TO: T10 Membership
FROM: Paul A. Suhler, Quantum Corporation
DATE: 18 December 2008
SUBJECT: T10/08-409r4, ADT-2: Internet ADT (iADT)

Figure 34 — Example Media Changer application of ADT

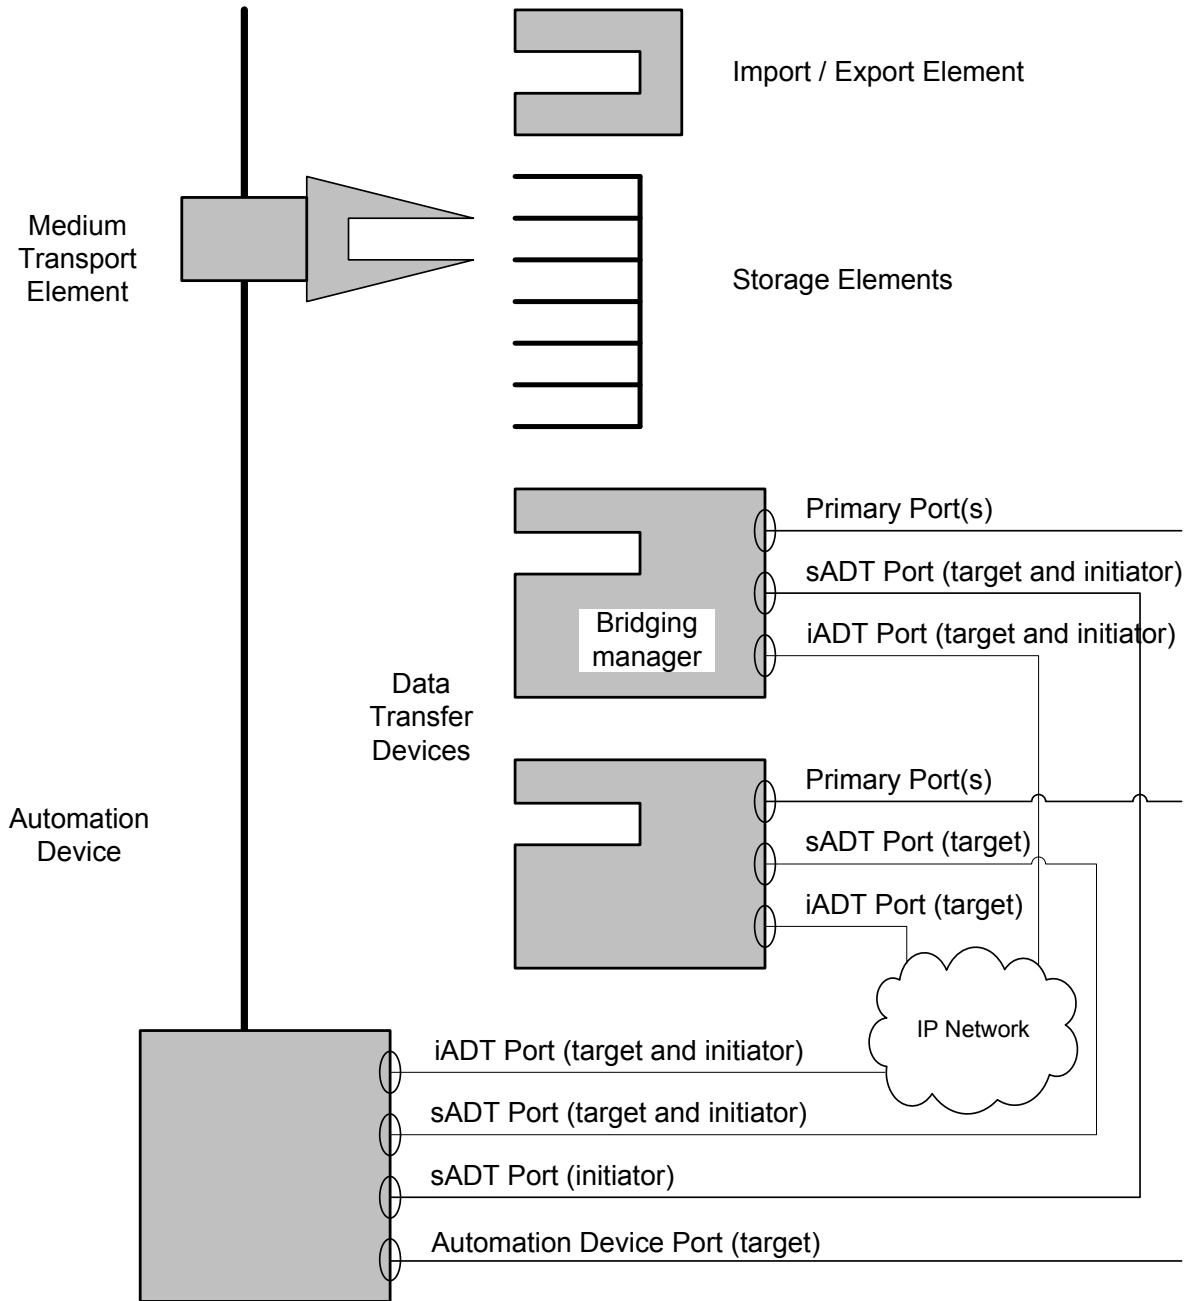
Figure 3 4 shows ~~an example of an ADT interface~~ examples of serial ADT (sADT) and internet ADT (iADT) interfaces (see 4.1.2) within a media changer containing two DT devices. Other common components of a media changer are also shown for reference. The components of an automation device are medium transport elements, data transfer (DT) devices, storage elements, and import/export elements (see SMC-3). The automation device communicates with the DT devices through ADT ports, as defined in this standard. DT devices and automation devices communicate with initiator ports other than those in the automation device using primary ports.

Note: A media changer would not necessarily use both sADT and iADT ports. They are both shown for comparison.

Figure 5 – ADT communication model

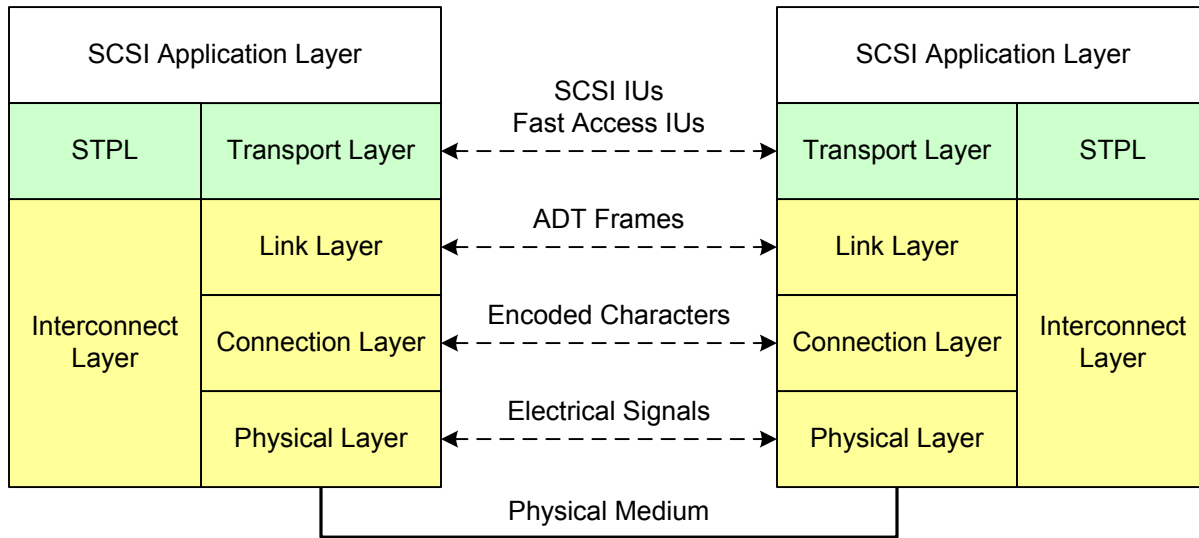
Figure 5 shows the communication between ADT ports at the different layers of the protocol, from the physical layer to the SCSI transport protocol layer.

Figure 18a – Connection services for establishing a connection between iADT ports

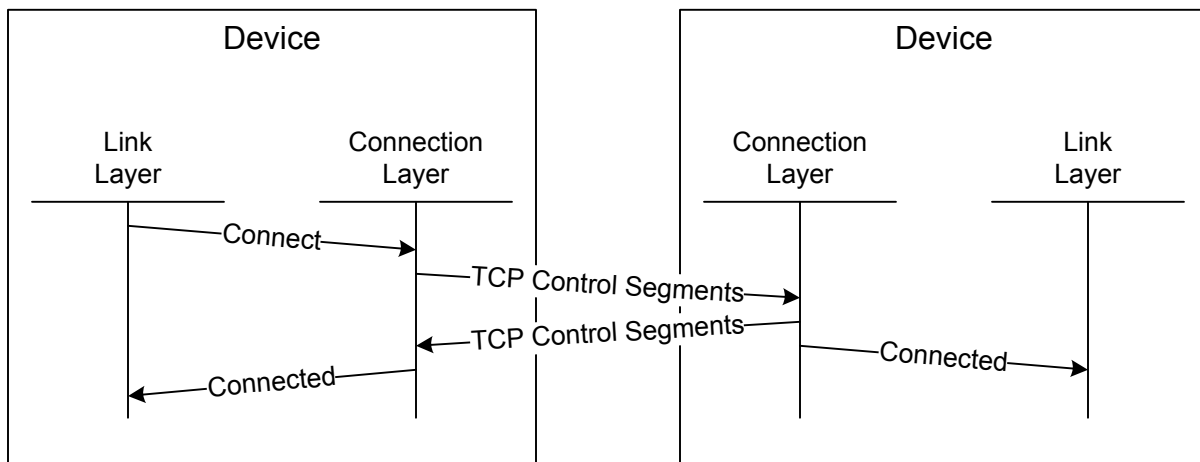
Figure 18a shows an example of the relationships among the connection services used to establish a connection between two iADT ports. The communication between the two devices is defined in RFC 793 and may constitute more than the two communications shown.

Note: I added the following paragraph after I added the “TCP control segments” labels to the inter-port communications in figures 18a and 20a, in case there were questions about the communications in Figure 19. Is this necessary?

Figure 20a – Connection services for closing a connection between iADT ports

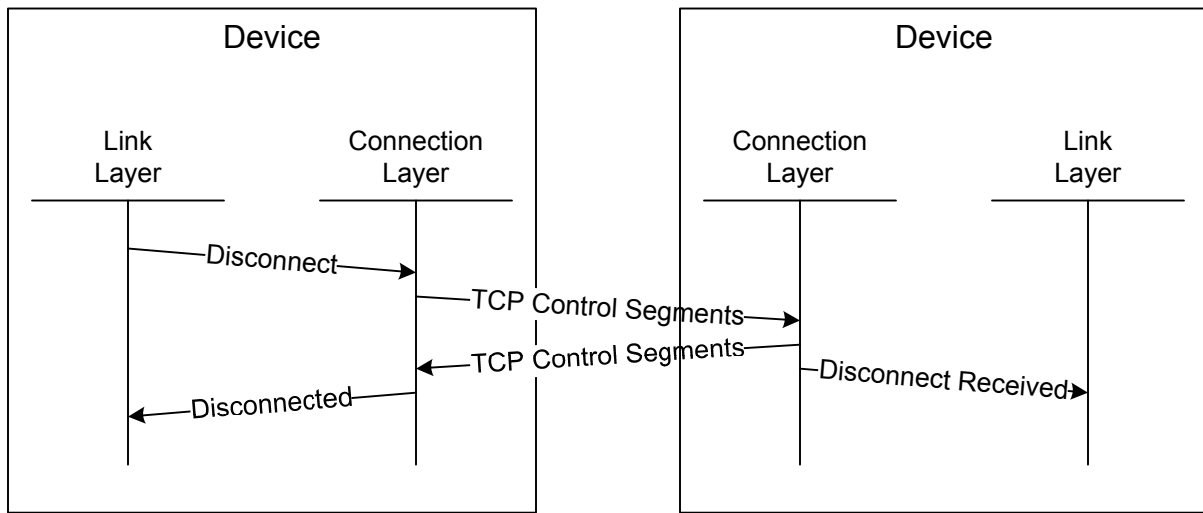
Figure 20a shows the relationships among the connection services used to close a connection between two iADT ports. The communication between the two devices is defined in RFC 793 and may constitute more than the two communications shown.
